Informal meeting on Code of Practice for Packing of Cargo Transport Units

Updates to the CTU Code

Transport of liquids

This document proposes possible changes to Section 5.2 Flexitanks

Figure 1 - Flexitank Transport Process – Cargo

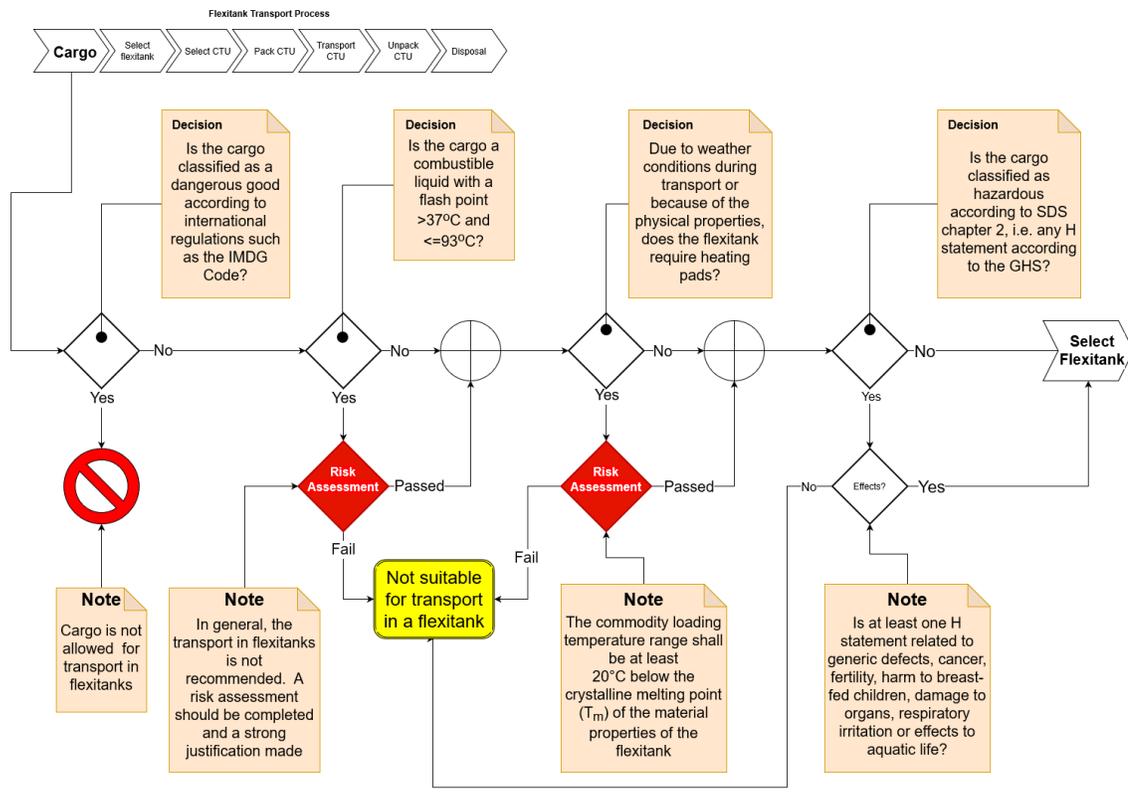
[When considering whether a commodity is suitable for transport in a flexitank consider the following process:](#)

Figure 10 – Flexitank transport Process - Flexitank selection

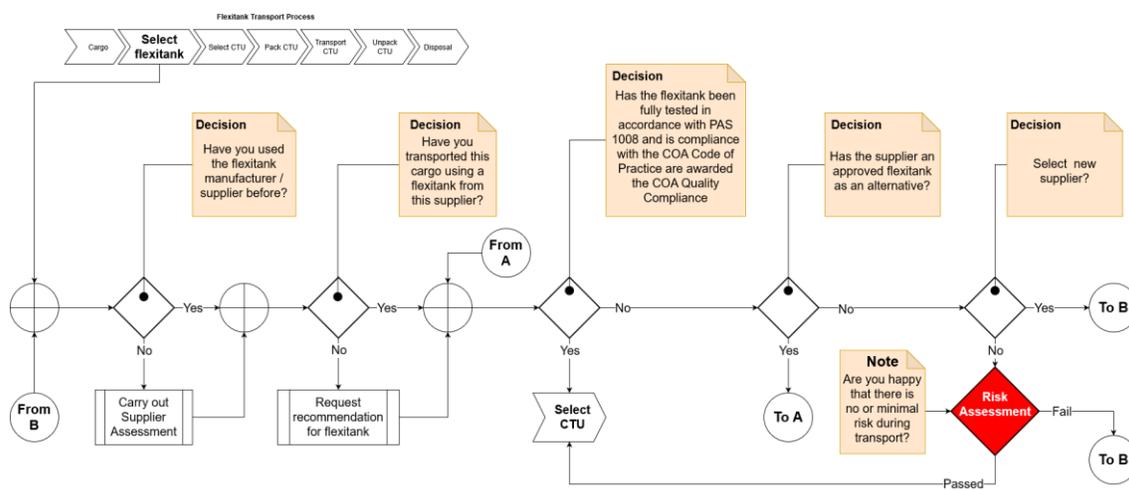
The material used to construct the flexitank and valves etc. must be compatible with the intended cargo; the compatibility of new commodities must be tested in advance. Where a new commodity has similar chemical properties to other cargoes already being carried, further compatibility testing may not be required.

Figure 2 – Flexitank transport process - CTU Selection

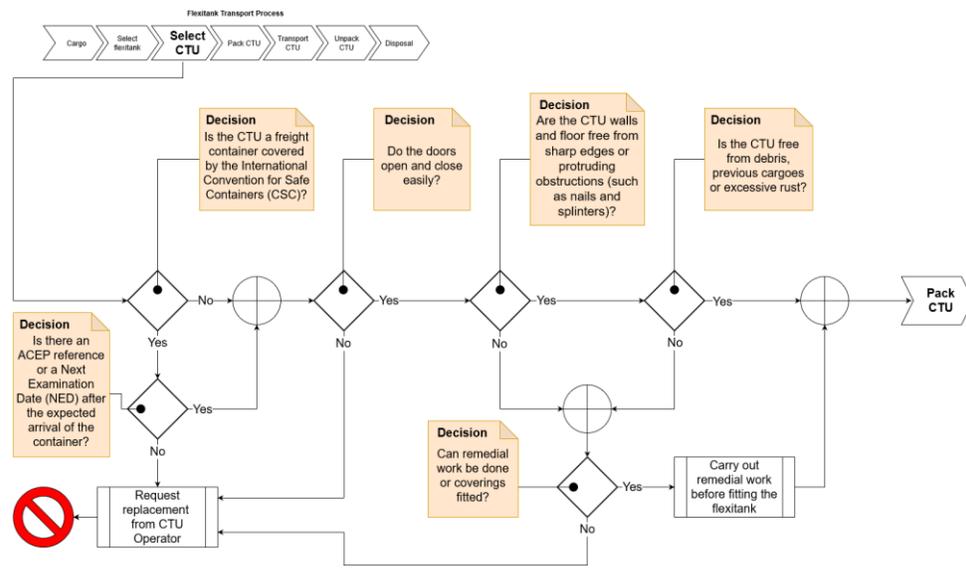
On arrival the CTU should be checked in accordance with Chapter 8, sections 1 and 2 of the IMO/ILO/UNECE Code of Practice for Packing of Cargo Transport Units (CTU Code)¹. Deficiencies to the Safety Approval Plates, to the structural integrity of the CTU or its suitability for installing or transporting a flexitank should be notified to the CTU operator and returned for replacement.

Figure 3 - Flexitank transport process – Packing

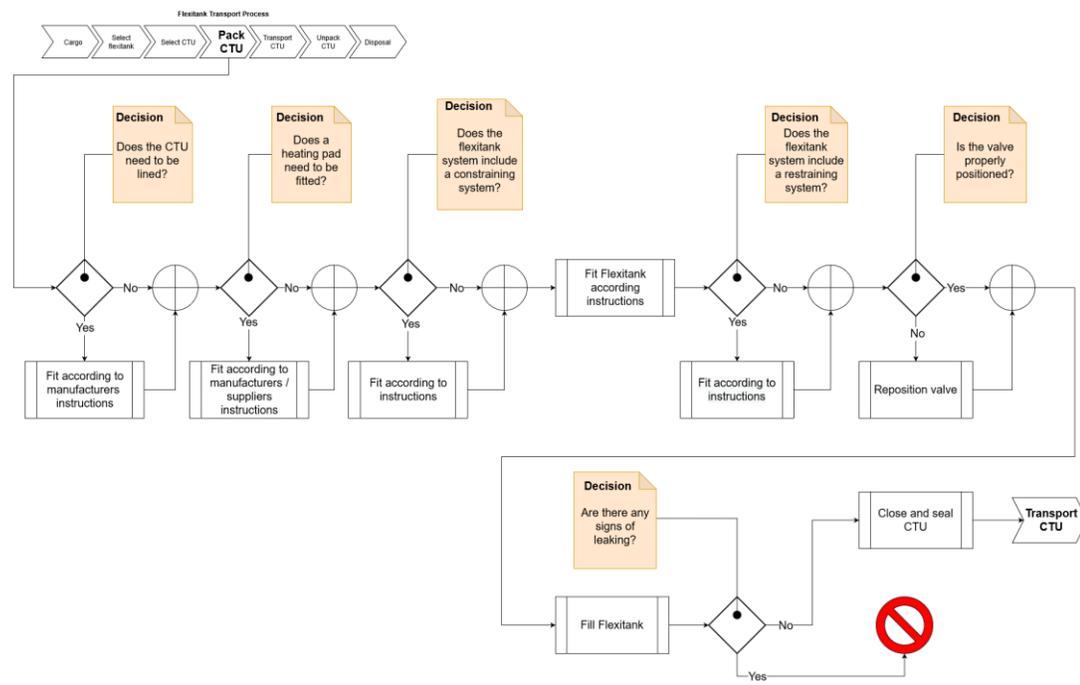
Before the flexitank is filled, the CTU must be prepared:

Figure 4 - Flexitank warning triangle

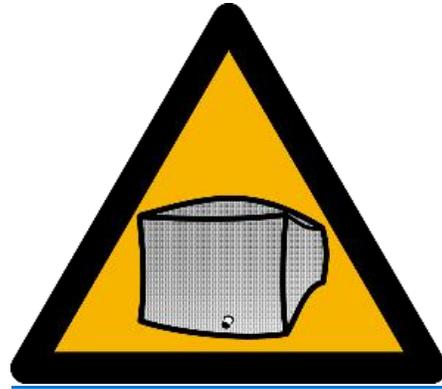
the CTU should be marked with a Container flexitank warning mark on outside of the rear left-hand door, a warning triangle should be applied to the remaining three sides of the CTU (see Figure 4) and both ends of the roof.

Figure 6 - Positioning flexitanks

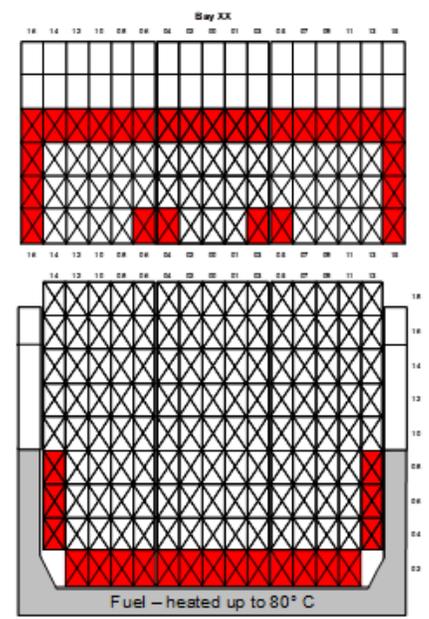
Containers packed with a flexitank can be loaded on ships and ship planners would normally place containers with a heavy gross mass as low as possible, however when positioning these containers, the planner should consider that: **How does the operator ensure this with carriers?**

- Above deck, containers with flexitanks should not be stowed in the outer and upper most slots as or at the edges of deck covers (red slots above deck in Figure 6) as.
